Chapin Ave. Burlingame

March 27 2025 Planning Commission Study Session Comments & Responses

Roller Shades
Example: Thesis (LEVER Achitecture)

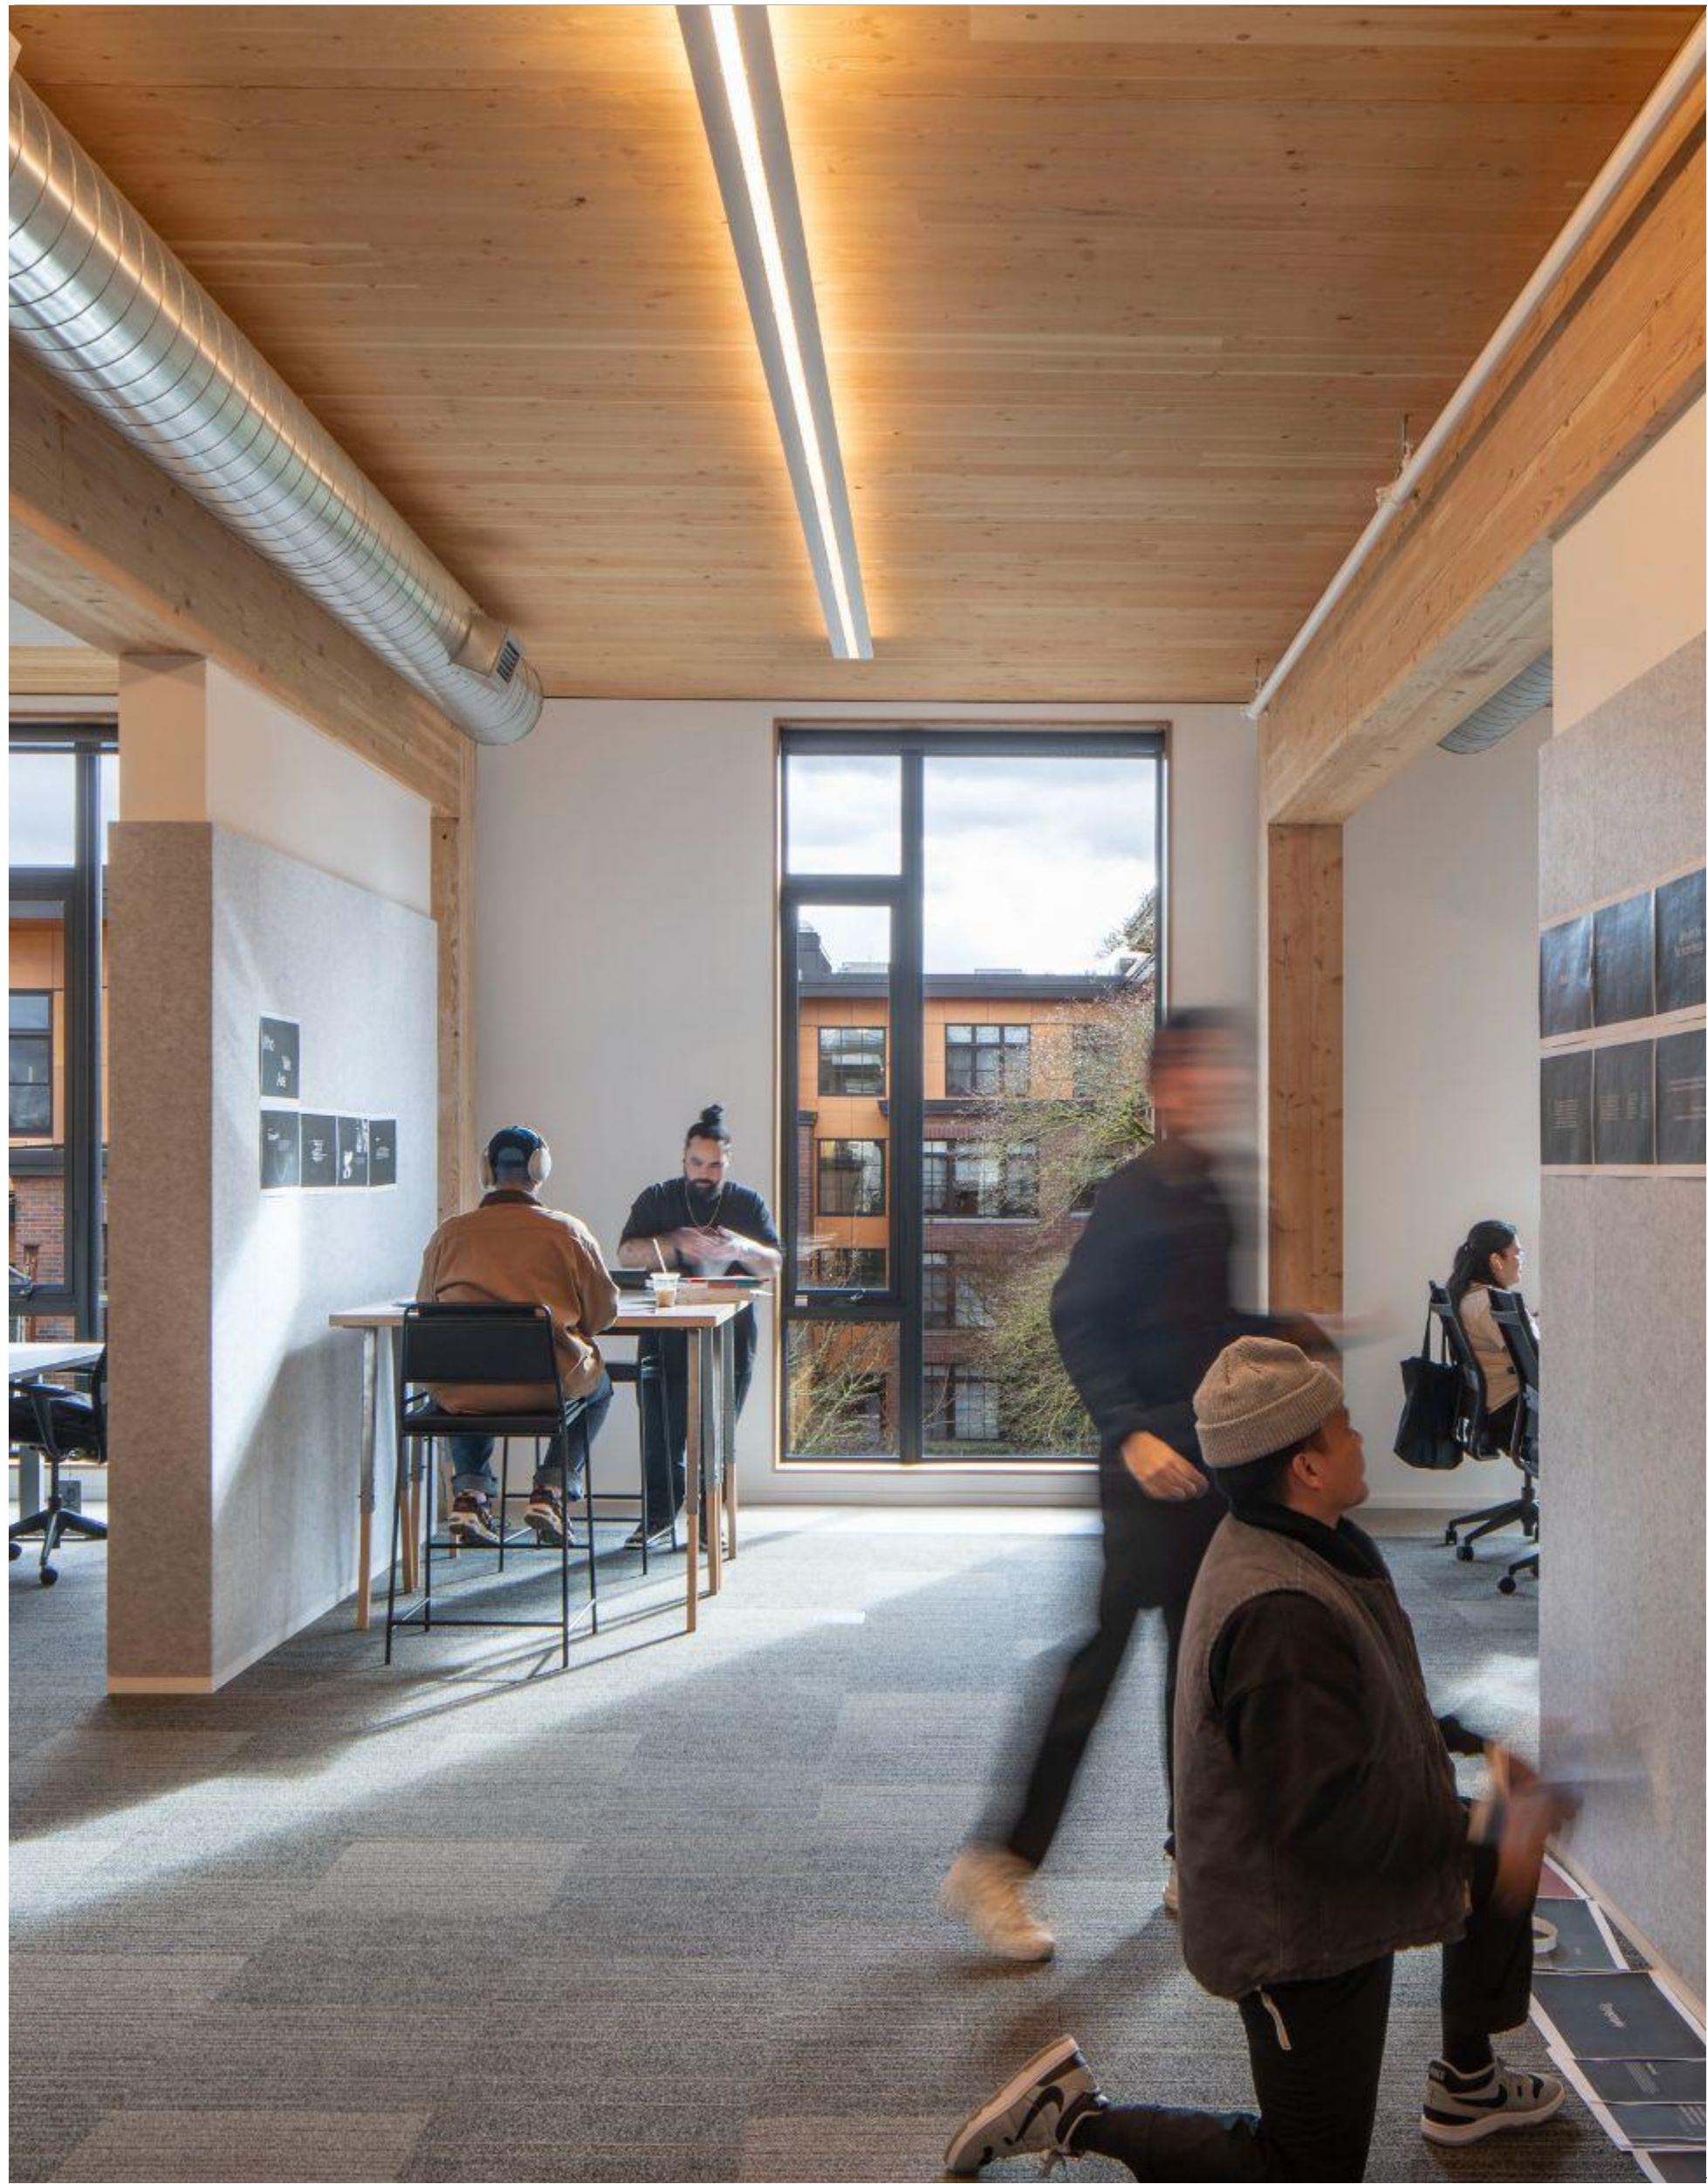
Address how window coverings are considered and the sun shaded in some logical way that it does not detract from the timber.

In addition to the built-in shading strategies incorporated into the façade, the building will utilize roll-down shades to enhance energy efficiency and manage light spill. These shades will be deployed in a way that does not obstruct the visibility of the mass timber. A core design intent is for the timber structure to remain visible from both the streetscape and the interior, ensuring the building feels organic and provides an experience unlike traditional construction.

Wood exposed between window shades
5% Roller shades, with transparency

Sun Studies | Shadow Direction Throughout The Day

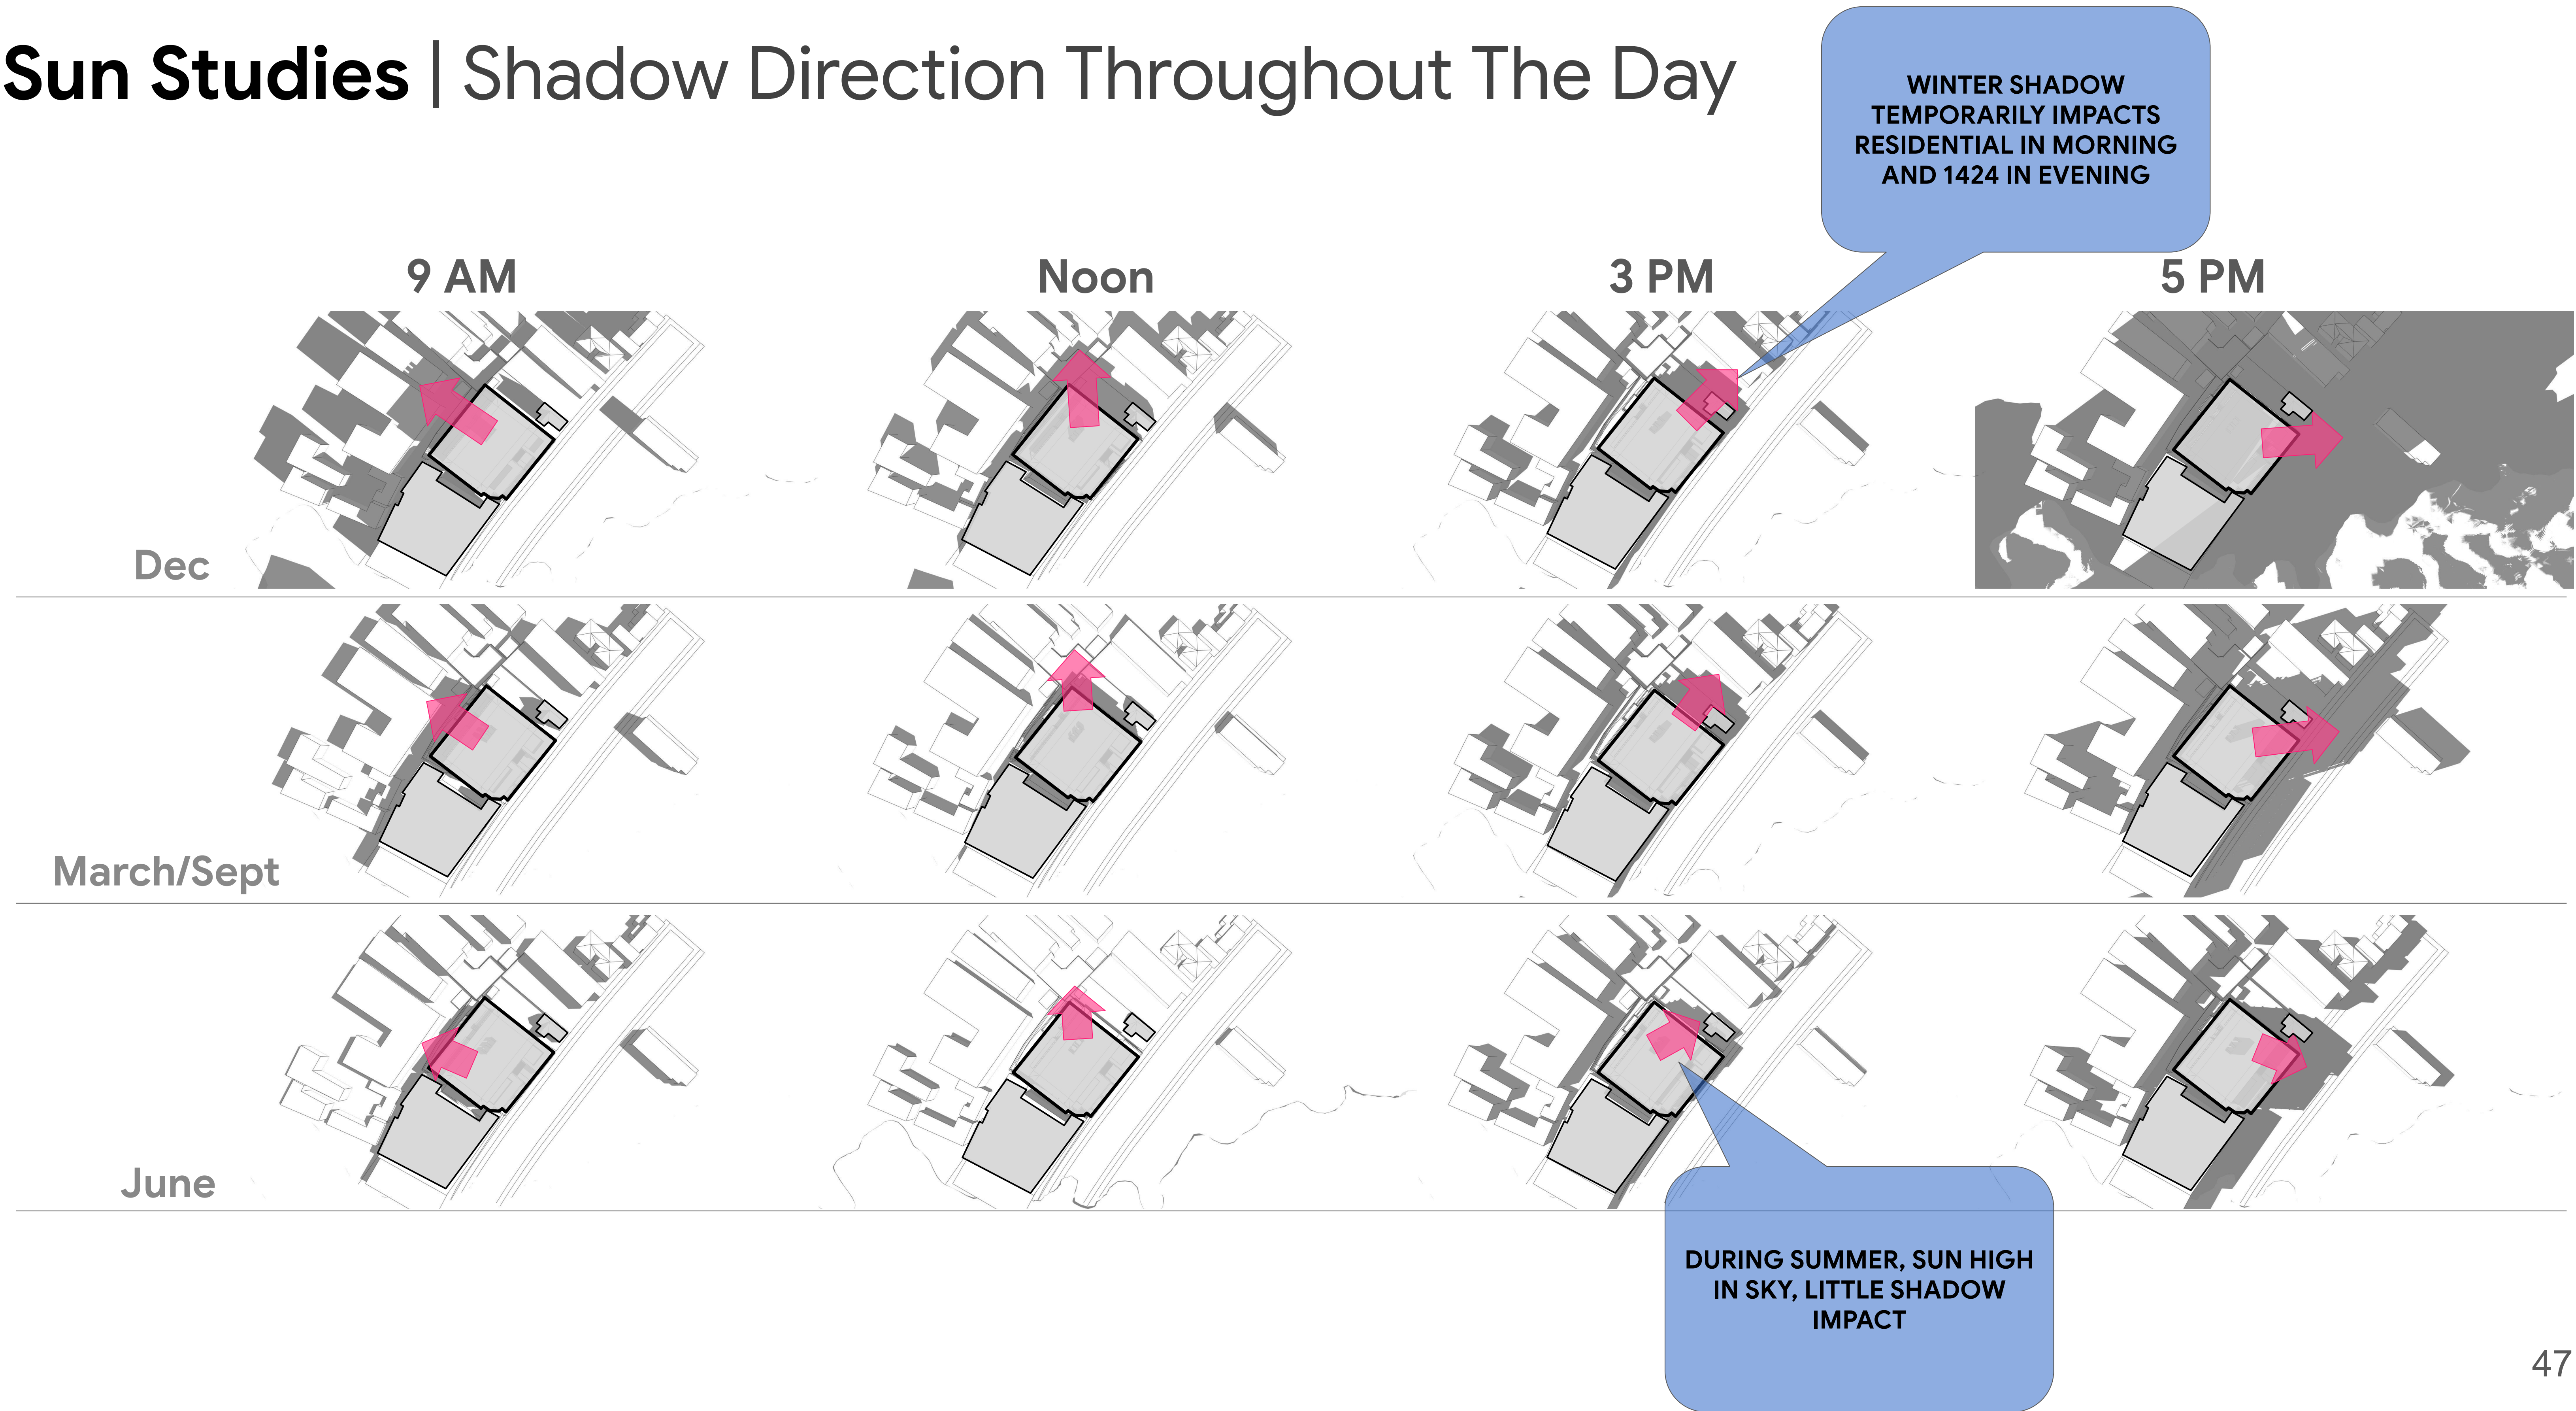
Provide a more detailed shadow study to show existing conditions.

A detailed shadow study was prepared to illustrate the impacts of the proposed development on adjacent properties throughout the year. The analysis demonstrates that the project creates minimal shading effects on surrounding buildings and open spaces.

From January through September, the proposed building does not materially shade the residential properties to the north along Ralston Avenue. During the winter months (as modeled in December, when daylight is shortest), the adjacent residences experience partial shading between approximately 9:00 a.m. and noon, with sunlight returning to the properties by mid-afternoon.
